ESP32-P4 series v3.2 chip version upgrade

v1.3 Requirements Gathering and Discontinuation Plan Explanation

PCN Number	PCN202600801	Date of submission	2026/05/20
PCN No.		Issue Date of PCN	
PCN type	Customer Approval Required		
PCN Category	Customer Notification

Component mounting and adjustment diagram:

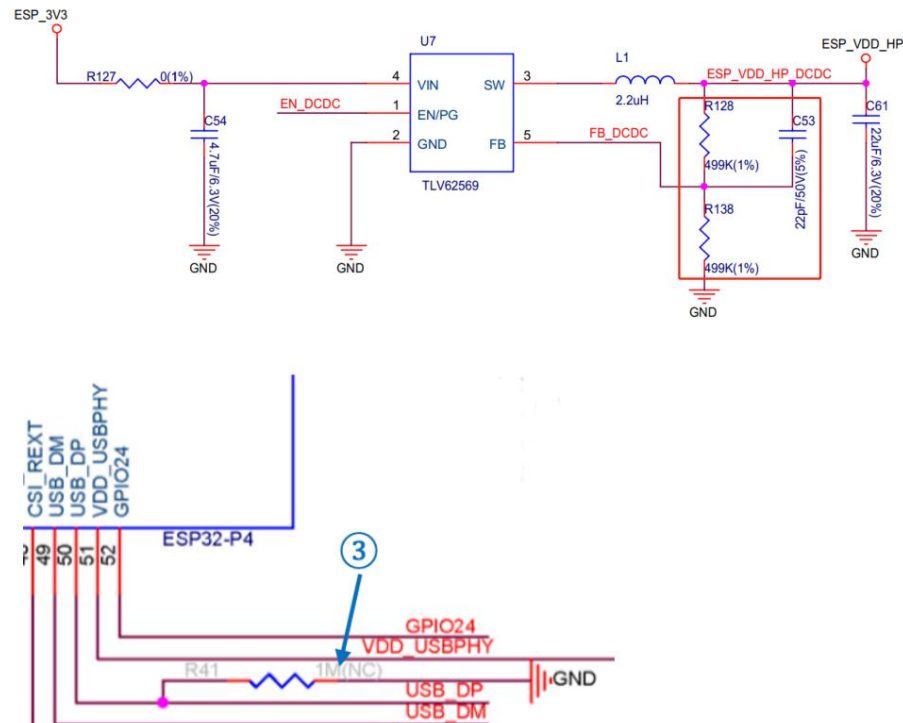
ü PCB design needs adjustment:

The newly added power pin (Pin 54) requires an external VDD_HP power supply; otherwise, it may affect USB, SDIO, and GMAC.

ü Component placement requires adjustment:

ý For the DC-DC power supply chip connected externally to the VDD_HP power supply, ensure that the two 499 chips around it are properly connected.

The ký feedback voltage divider resistor must be installed; otherwise, there is a risk of chip damage.

ý Feedforward capacitor: Please refer to the 22 pF feedforward capacitor on the C53. ý

The 1 Mý resistor needs to be removed from the USB_DP pin.

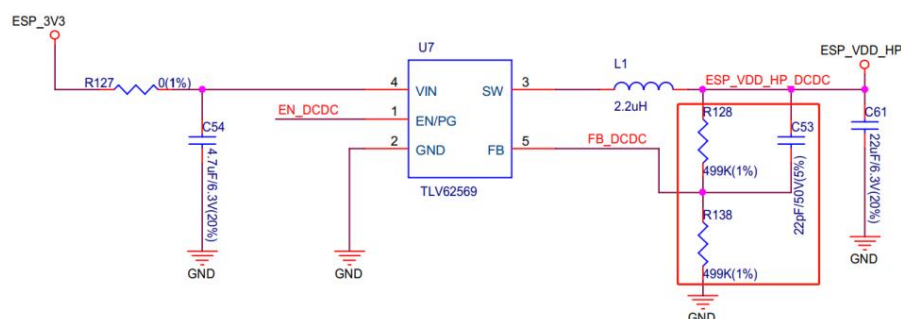
ü PCB design must be updated:

Pin 54 must be connected to VDD_HP externally; otherwise, the normal operation of the USB, SDIO, and GMAC modules may be affected.

Component placement adjustment diagram:

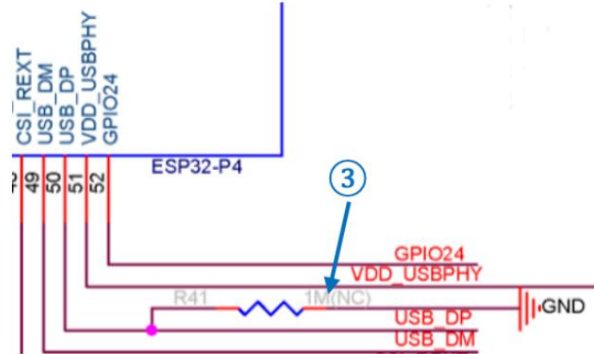
ü Component placement must be updated:

ÿ For the DCDC connected to VDD_HP externally, **ensure both 499 k Ω feedback resistors are populated, or the chip may be damaged.**

ÿ **Feedforward capacitor: populate 22 pF on the C53 feedforward capacitor.**

ÿ USB_DP pin: remove the 1 M Ω resistor.
